Re: Comments of The Utility Reform Network on NEM Cost-Benefit Phase 1 Scope
and Method

Pursuant to the directions provided by Energy Division, the Utility Reform Network (“TURN”) submits these informal comments on the propose Phase 1 study methodology, as explained in the October 16, 2012 paper prepared by Energy and Environmental Economics, Inc. (“E3 Study”). The E3 report explains that E3 will generally use the methodology prepared for the 2010 cost-effectiveness report, but with more detailed customer calculations of load and generation profiles, and more detailed individual bill impacts, based on greater availability of metered data.

These characteristics are illustrated most vividly in Figure 6-2 of the 2010 CSI Impact Evaluation Report, reproduced below:

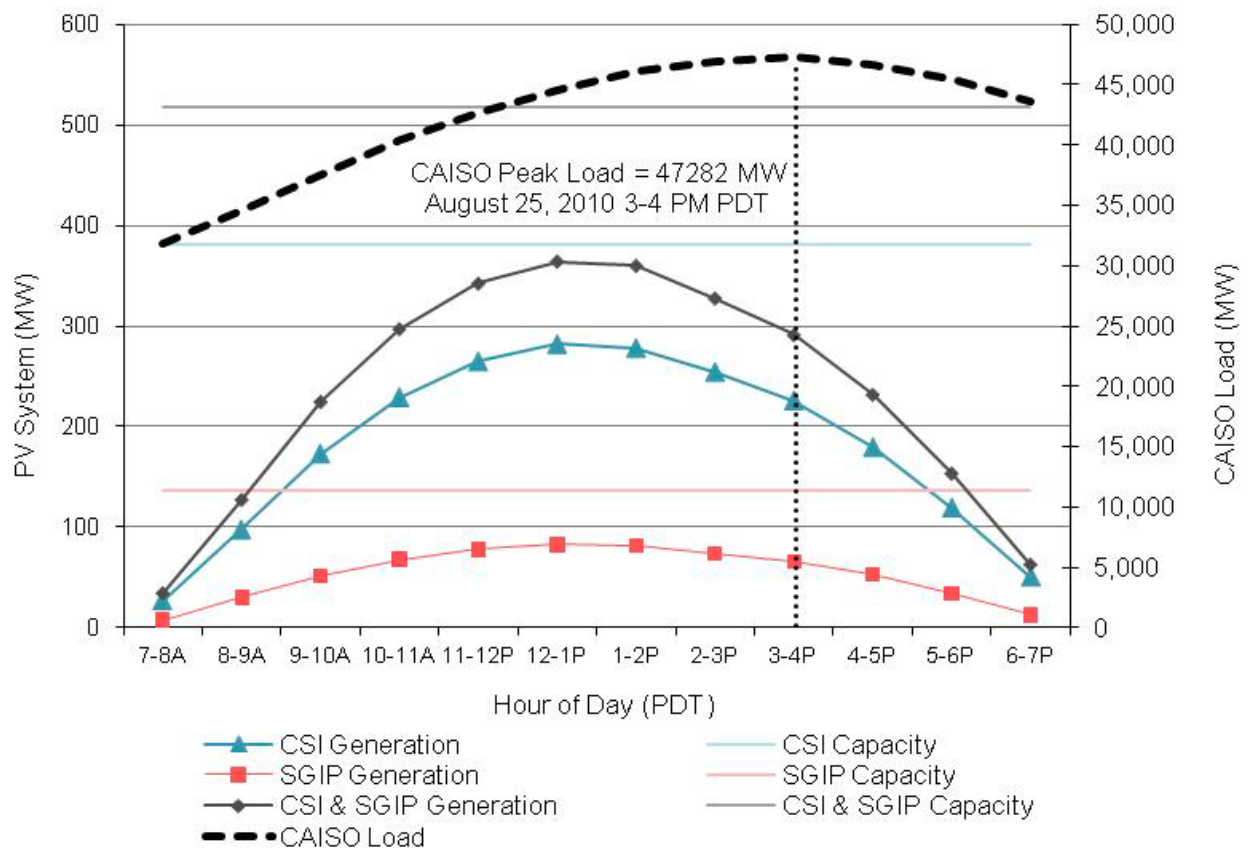
TURN strongly recommends against using this methodology to allocate distribution capacity costs for residential net-metering customers. The essential problem is that electrical circuits that are exclusively or primarily residential load generally peak during 6:00-7:00 p.m., much later than the system peak, which generally occurs during the 3:00-4:00 p.m. hour.⁴ Solar output peaks during 12:00-1:00 and declines significantly with time. Thus, solar output on residential circuits provides very little generation capacity that could offset distribution circuit assets designed to serve peak circuit load for that circuit. The only avoidable distribution capacity would be farther away from the customer, perhaps at a substation serving a mix of customers.

This figure shows that while the average CSI peak system hour capacity factor is about 60%,⁵ the corresponding CSI capacity factor during hour 6-7 is only about 13%.⁶

The use of geographic load averaging – by using weather for an entire climate zone – and comparing such allocation to generation output profiles, significantly masks the differential peaking time of residential versus commercial circuits.

Simply put, rooftop solar generation may provide some capacity benefit (i.e. defer planned distribution capacity investments) on commercial circuits, but provides very little such benefit on residential circuits.

TURN Recommendation: The E3 methodology should be modified to exclude distribution capacity benefits from the calculations for the residential customer class.

Alternatively, the methodology should be modified to make it circuit specific with circuit load data.
